Access Compliance Report

Public Rights-of-Way

(Curb Ramps)

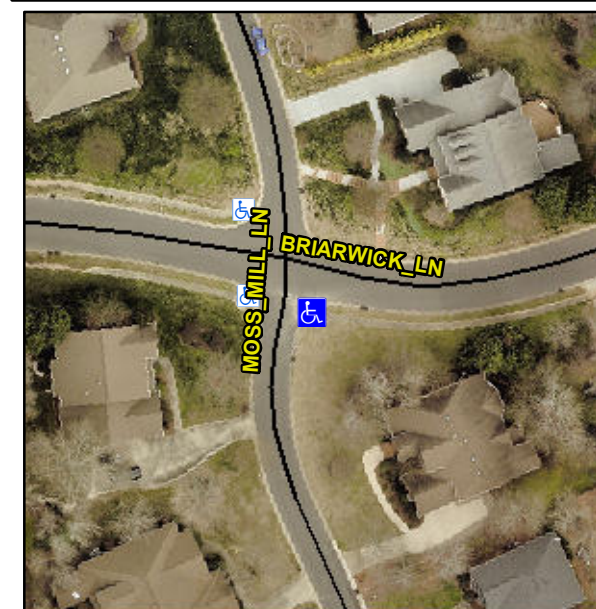
Intersection ID: 27777	Main Street: BRIARWICK_LN	Cross Street: MOSS_MILL_LN	Location: SE
ADA ID: A8E913D47E9B	Ramp Type: PerpDiag	Initial Pass/Fail: Fail	Overall Compliance: No
Severity Score: 12.5			
Codes/Mitigation Info/Possible Solution		Field Measurements/Component Compliance

PROW/ADA:

R304.2.2

Possible Solutions:

Remove & Replace Curb Ramp With Two New Directional Ramps or Equivalent.
